Case Number: R18045

**CASE COMMENTS:**

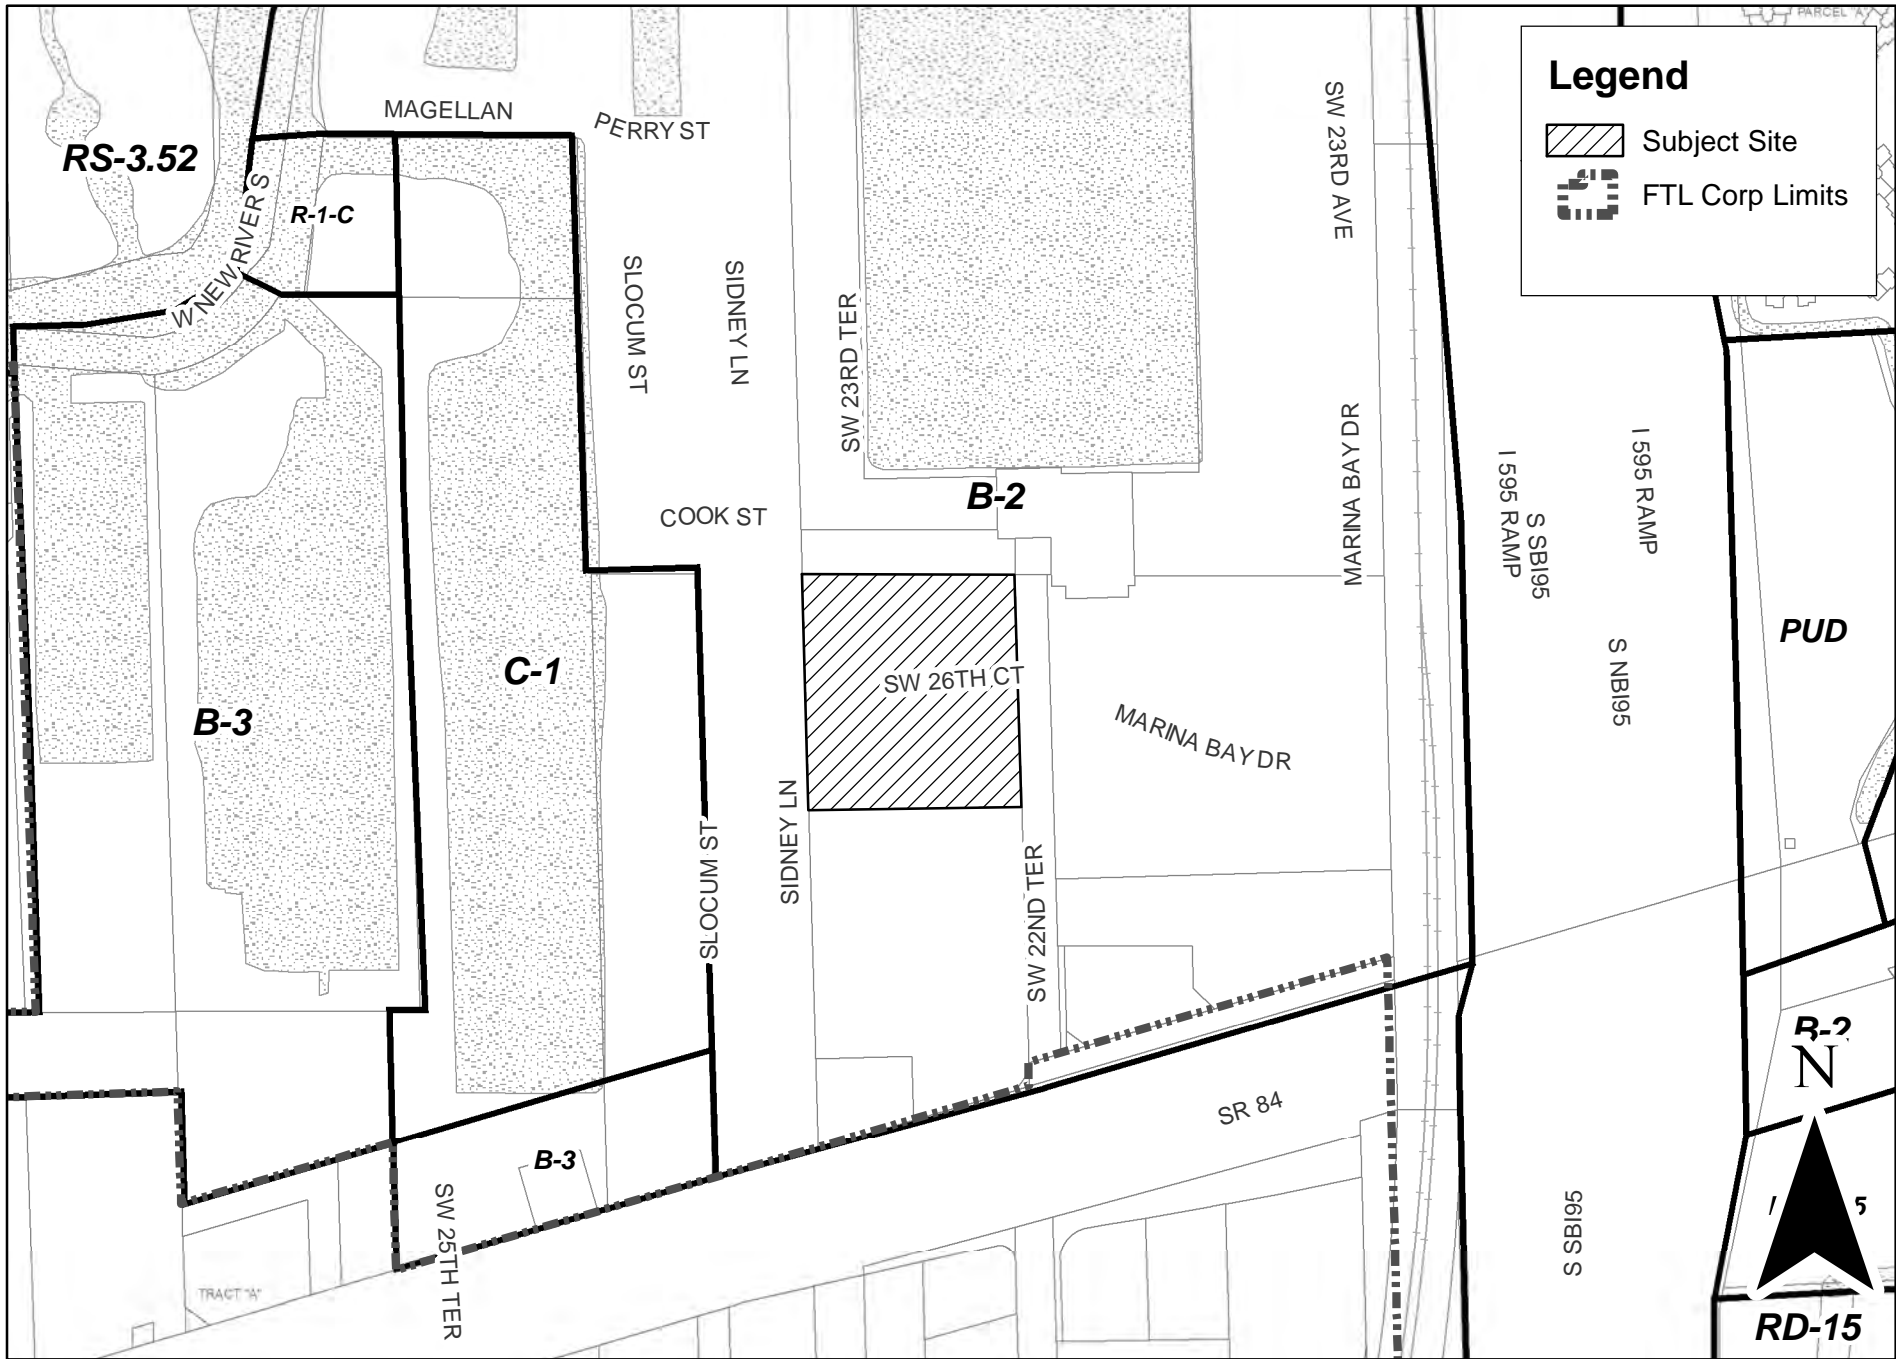
8. Provide the following changes on site plan:
  - a. Provide detail of proposed public plaza and demonstrate compliance with Sec. 47-18.21.H, Landscaping and open space requirements;

- b. Consider reducing the number of curb cuts along SW 22nd Terrace;
  - c. Consider revising the layout to reduce vehicular presence on site by consolidating the parking in the garage and allowing for increased landscape;

- d. Provide dimensions of the parking stalls;
  - e. Provide location of trash receptacles or dumpsters; discuss location with solid waste and recycling representative. Show typical trash container dimensions and location for each unit; and

- f. Indicate all utilities (both above and below ground) that would affect the proposed planting or landscape plan. Overhead lines (if any) should be placed underground. If the lines cannot be placed underground, provide documentation from Florida Power & Light Company indicating such.
